ENTERGY OPERATIONS, INC.  
SYSTEM ENERGY RESOURCES, INC.  
SOUTH MISSISSIPPI ELECTRIC POWER ASSOCIATION  
MISSISSIPPI POWER AND LIGHT COMPANY  
DOCKET NO. 50-416  
GRAND GULF NUCLEAR STATION, UNIT 1  
AMENDMENT TO FACILITY OPERATING LICENSE

Amendment No. 93  
License No. NPF-29

ATTACHMENT TO LICENSE AMENDMENT NO. 93

Replace the following pages of the Appendix A Technical Specifications with the attached pages. The revised pages are identified by amendment number and contain vertical lines indicating the area of change.

FIGURE 3.2.3-1 MCPR<sub>f</sub>

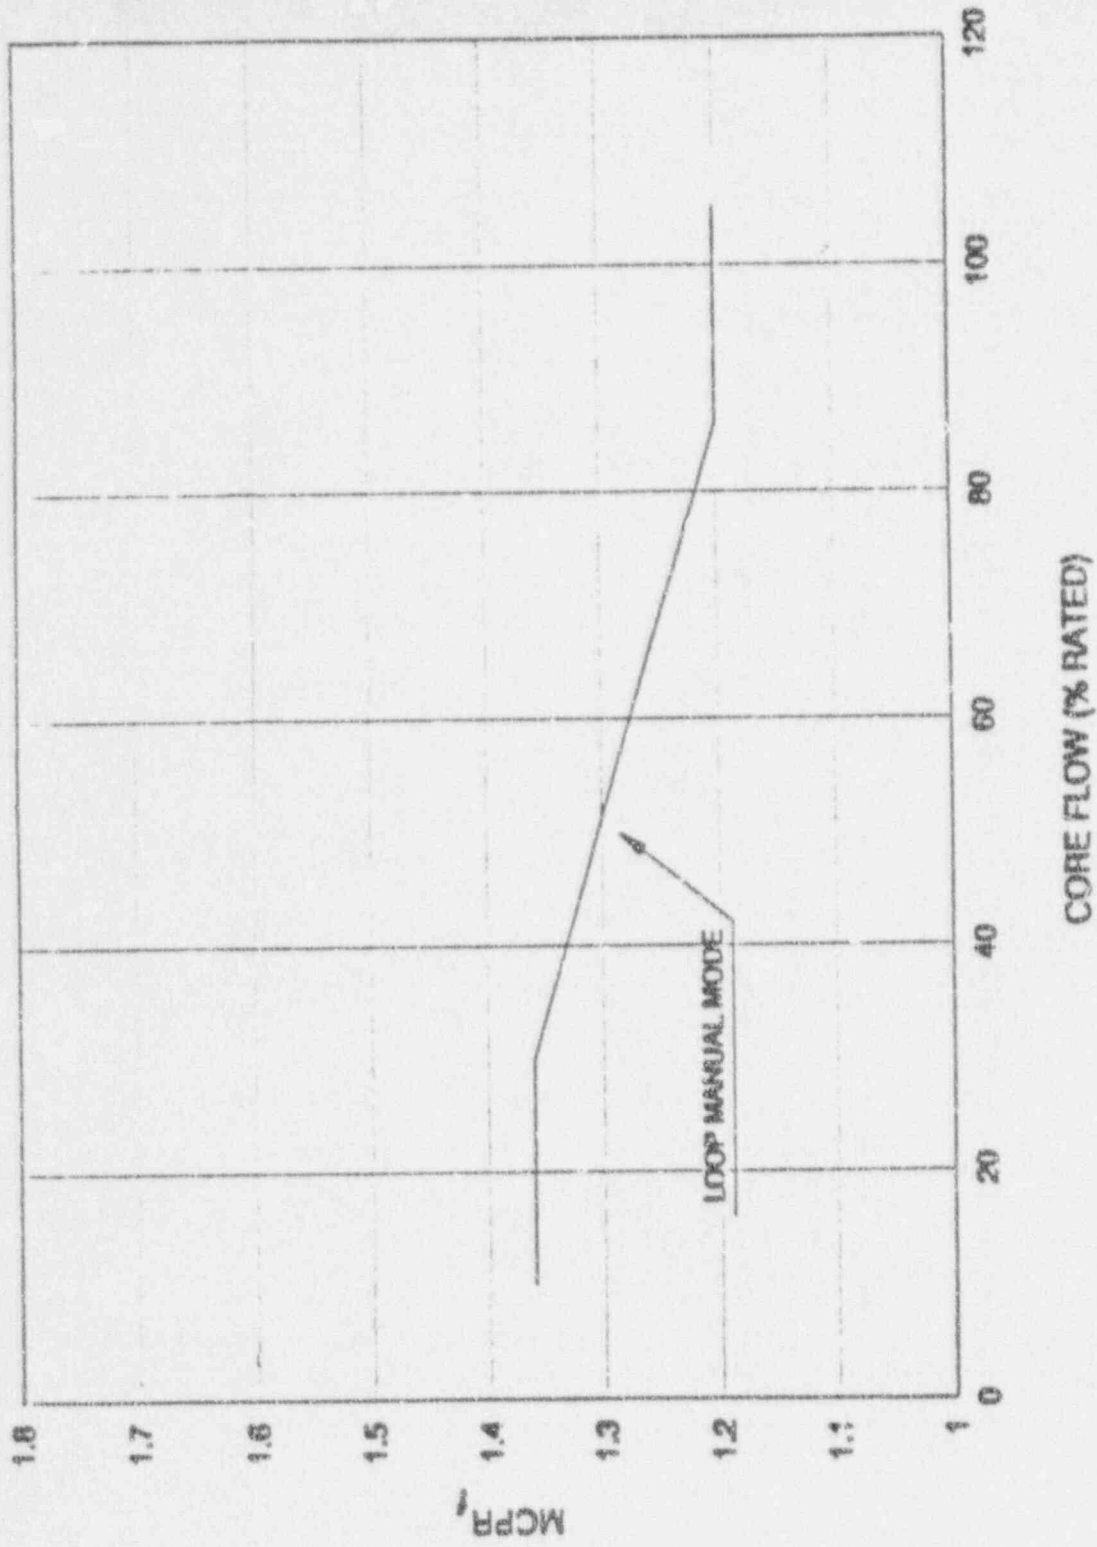
The purpose of the  $MCPR_f$  and  $MCPR_p$  is to define operating limits at other than rated core flow and power conditions for all exposures during the cycle.

The  $MCPR_f$ s are established to protect the core from inadvertent core flow increases such that the 99.9% MCPR limit requirement can be assured. The reference core flow increase event used to establish the  $MCPR_f$  is a hypothesized slow flow runout to maximum, that does not result in a scram from neutron flux overshoot exceeding the APRM neutron flux-high level (Table 2.2.1-1 item 2). The result of a single failure or single operator error during Loop Manual operation is the runout of one loop because the two recirculation loops are under independent control. With this basis, the  $MCPR_f$  curve was generated from

a series of steady state core thermal hydraulic calculations performed at several core power and flow conditions along the steepest flow control line. In the actual calculations a conservative highly steep generic representation of the 105% steam flow rodline flow control line has been used. Assumptions used in the original calculations of this generic flow control line were consistent with a slow flow increase transient duration of several minutes: (a) the plant heat balance was assumed to be in equilibrium, and (b) core xenon concentration

was assumed to be constant. The generic flow control line is used to define several core power/flow states at which to perform steady-state core thermal-hydraulic evaluations.

The Loop Manual mode of operation was analyzed. Consistent with the single failure/single operator error criterion, one loop runout was postulated for Loop Manual operation. The maximum core flow at loop runout was assumed to be 110% of rated flow. Peaking factors were selected such that the MCPR for the bundle with the least margin of safety would not decrease below the MCPR Safety Limit.

FIGURE 3.2.4-2 LHGRFAC<sub>f</sub>

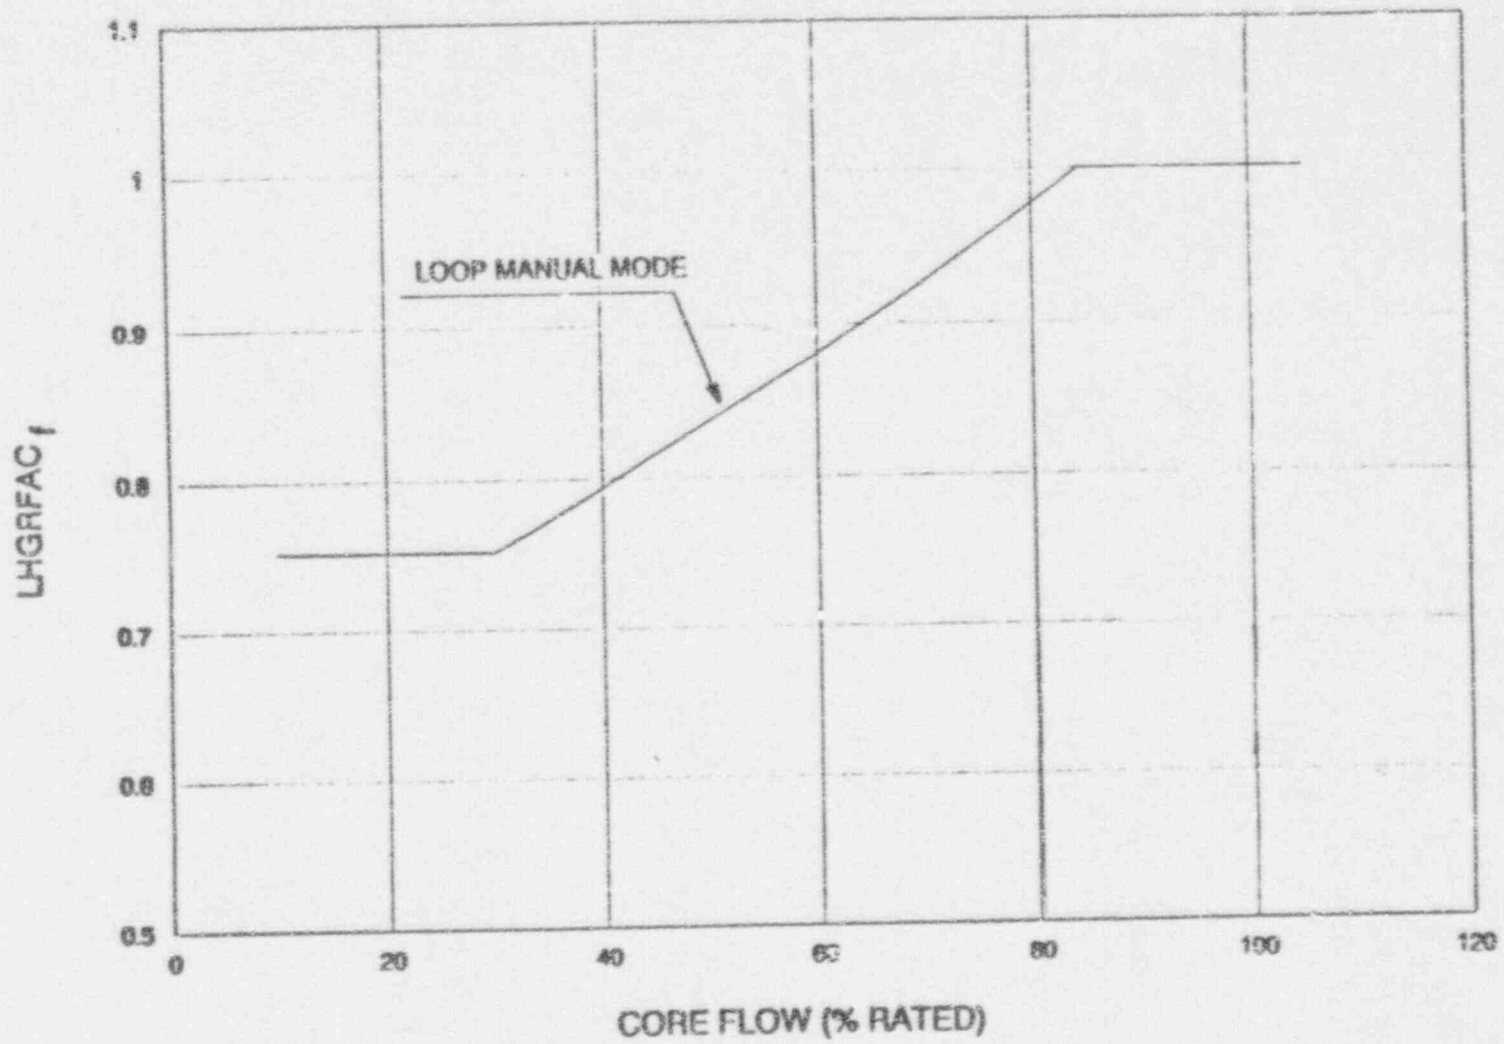
The LHGR limits of Figure 3.2.4-1 are multiplied by the smaller of either the flow dependent LHGR factor ( $LHGRFAC_f$ ) or the power dependent LHGR factor ( $LHGRFAC_p$ ) corresponding to the existing core flow and power state to ensure adherence to the fuel mechanical design bases during the limiting transient.  $LHGRFAC_f$ 's are generated to protect the core from slow flow runout transients. A curve is provided based on the maximum credible flow runout transient for Loop Manual operation. The result of a single failure or single operator error during operation in Loop Manual is the runout of only one loop because both recirculation loops are under independent control.  $LHGRFAC_p$ 's are generated to protect the core from plant transients other than core flow increases.
